REVIEW OF THE STATUS OF CRBR LICENSING TECHNICAL ISSUES
RELATED TO HEAT REMOVAL SYSTEM AND SEVERE ACCIDENT ANALYSIS

R. A. BARI, ET AL.

DATE PUBLISHED - APRIL 1982

Prepared for the U.S. Nuclear Regulatory Commission
Office of Nuclear Reactor Regulation
Contract No. DE-AC02-76CH00016

Figure 2.1 CRBRP Homogeneous and Heterogeneous Core Designs.

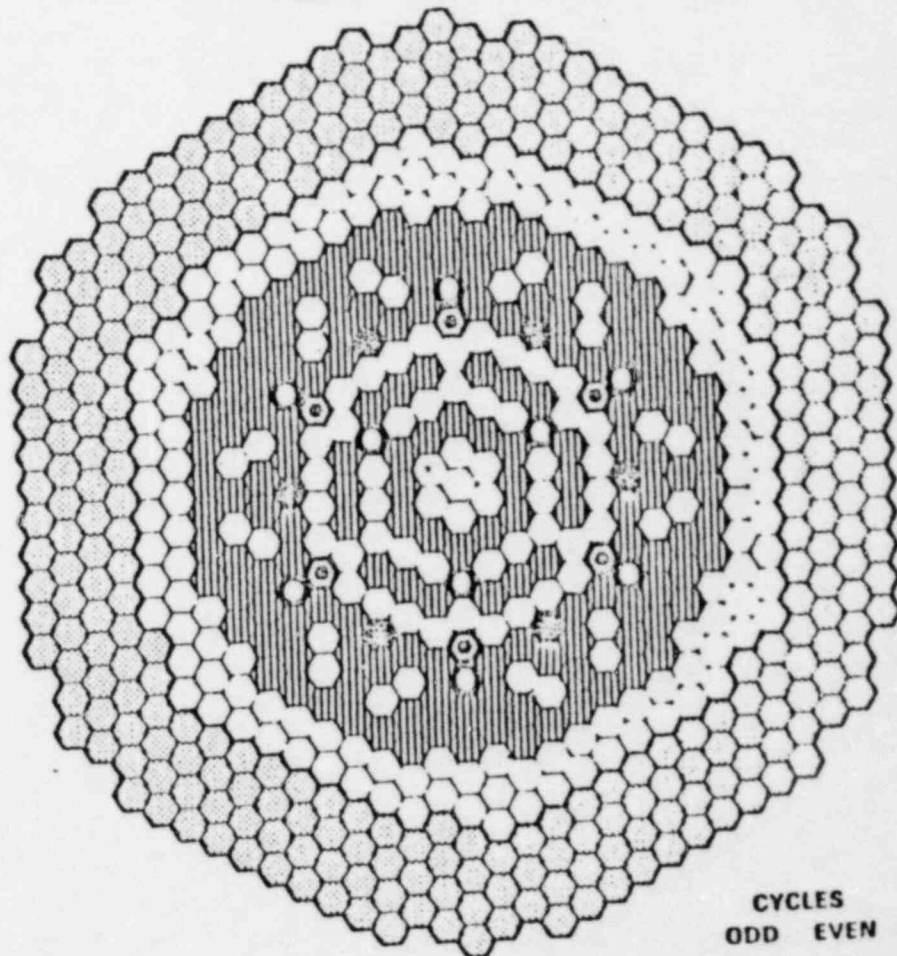
The CRBRP heterogeneous core differs from the previous homogeneous core in many ways. Figure 2.1 is a schematic of these two layouts (Refs. 2.1,2.2). The heterogeneous core uses 32.8% enriched fuel ($\text{Pu}/(\text{U}+\text{Pu})$), as opposed to 17.4 and 25.1% enrichment in the homogeneous core. The fissile inventory is also significantly larger (10 to 25%). At the same time, the CRBR Project stated that the control rod worth requirement is considerably lower for the heterogeneous core (\$17.44 primary for BOC4 as opposed to \$26.53 primary for the equilibrium cycle of the homogeneous core). The computation of the control rod worth and the available margin is a complex problem, as it requires two-space dimensions coupled with time kinetics computer codes (see Section 7). An independent assessment is needed to assure that the total available worth with one worst rod stuck will exceed, at all times, the required control rod reactivity.

Figure 3.3.4
DHRS Flow Operation

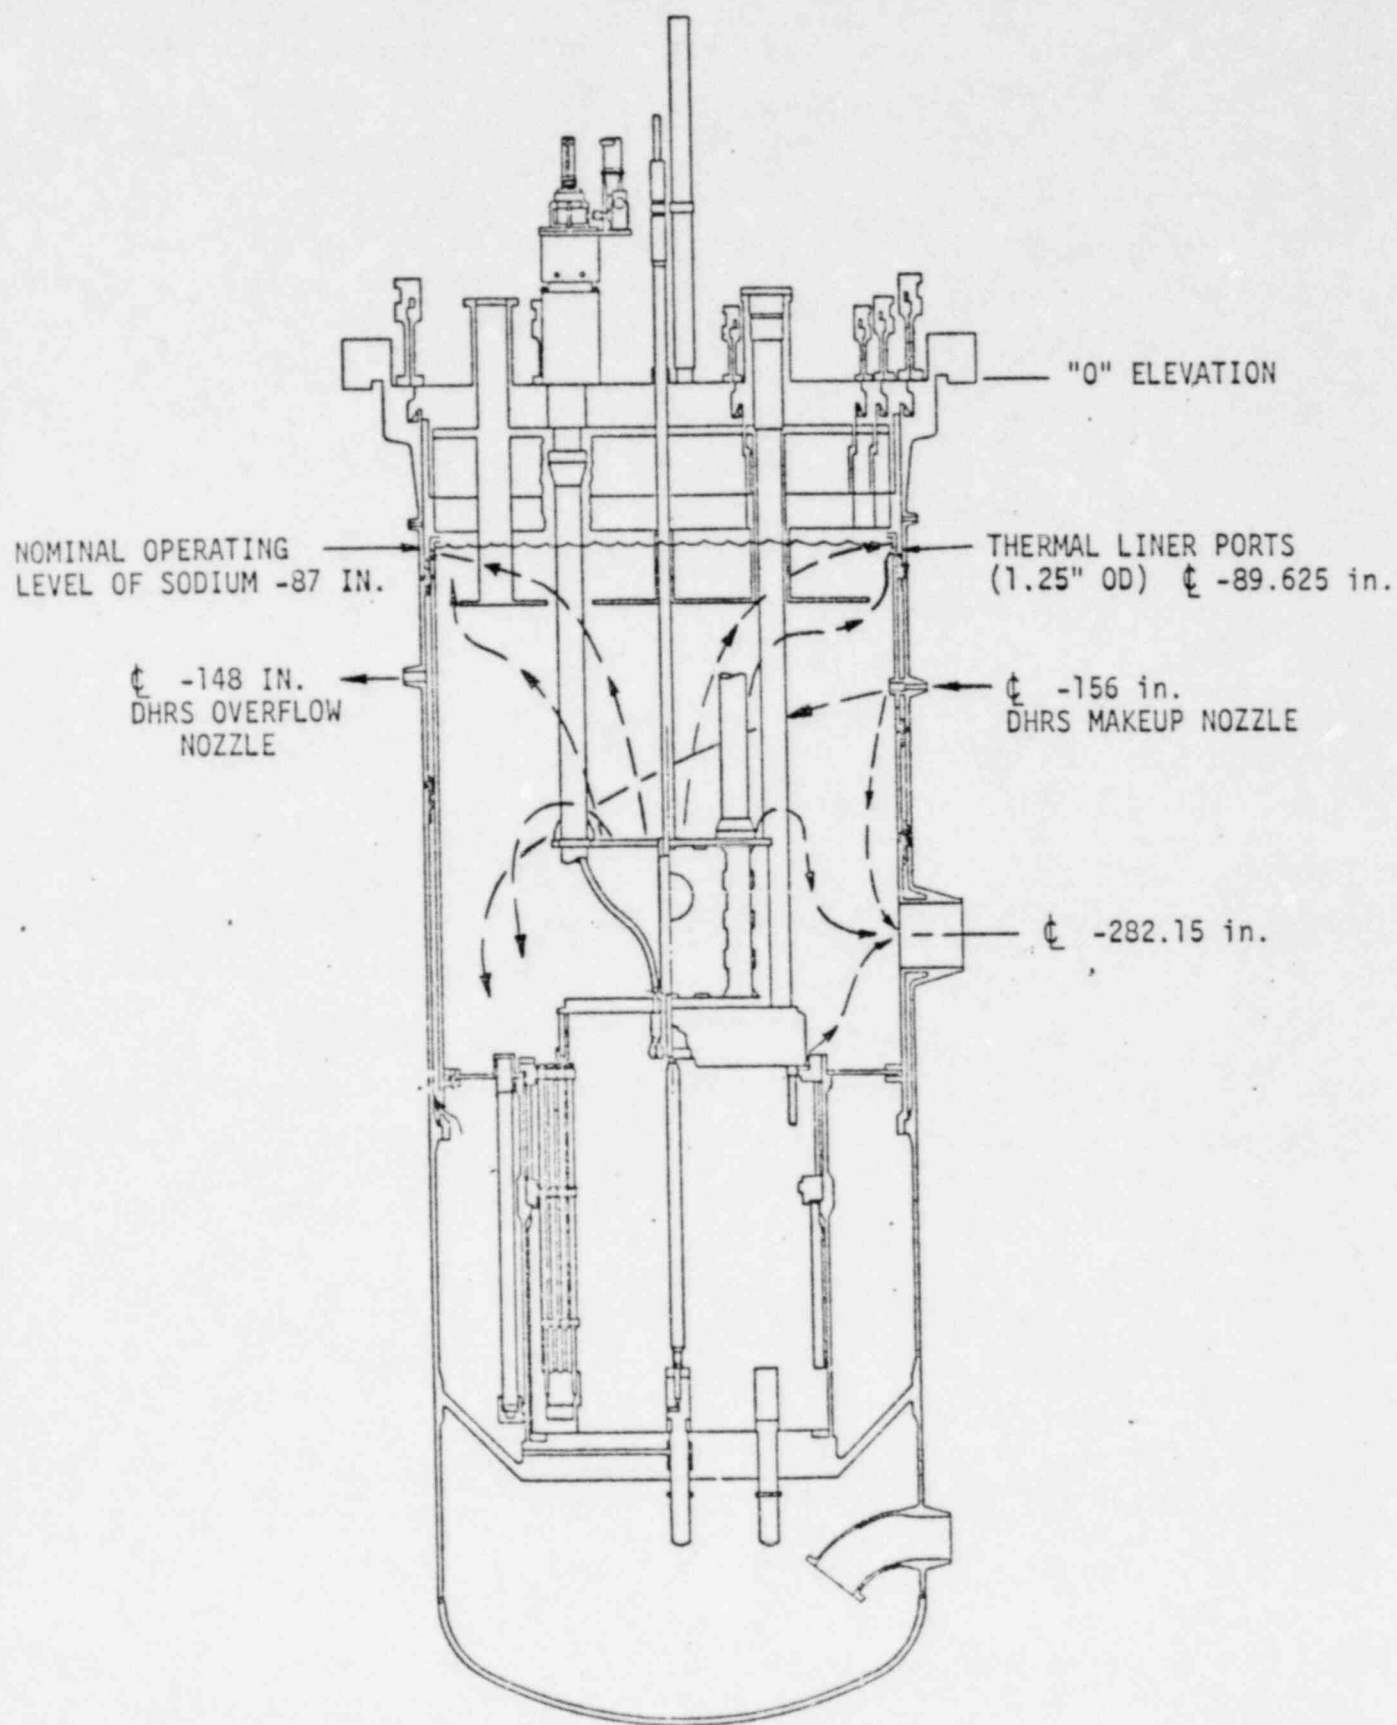
(1) Effect of Sodium Level: In the current design, the inlet to the DHRS (refer to Figure 3.3.4) is located behind the thermal liner (i.e., the inlet does not penetrate through the thermal liner). Sodium into the thermal liner originates from the bottom (which will essentially be cold sodium at the inlet plenum temperature) and from the top through thermal liner ports which are located only about 2.5 inches below the nominal sodium operating level. Consequently, the only source of upper plenum sodium to the DHRS will be through these highly elevated ports. Thus, the sodium level under required DHRS operation must be closely assessed. Additionally, the DHRS will offer no heat removal capability for any serious PHTS pipe break events.

(2) Upper Plenum Effects: The applicant currently assumes that the upper plenum sodium is well mixed, given that all PHTS pony motors are providing forced convection during DHRS operations. Current evidence (see also Section 3.1) indicates that this may not be the case. Since the only source of hot sodium received by the DHRS comes from the uppermost portion of the upper plenum (refer to Figure 3.3.4 and also to previous discussion under this subsection), the impact of stratification and subsequent heat removal capability must be investigated. Additionally, the outlet from the DHRS exits directly into the upper plenum through the thermal liner (refer to Figure 3.3.4) at a location

almost opposite from the inlet. The inlet stream velocity is around 6-10 feet/second. The applicant is claiming the usage of a conservative estimate, based on experimental evidence (see also Section 3.4) to provide an upper bound on the amount of cold sodium from the DHRS outlet which may potentially communicate directly with the DHRS inlet. This direct cross flow will limit the effectiveness of the DHRS and must be verified. Also, the admissible usage of data derived from water tests as applied to a sodium system under these circumstances must be addressed.
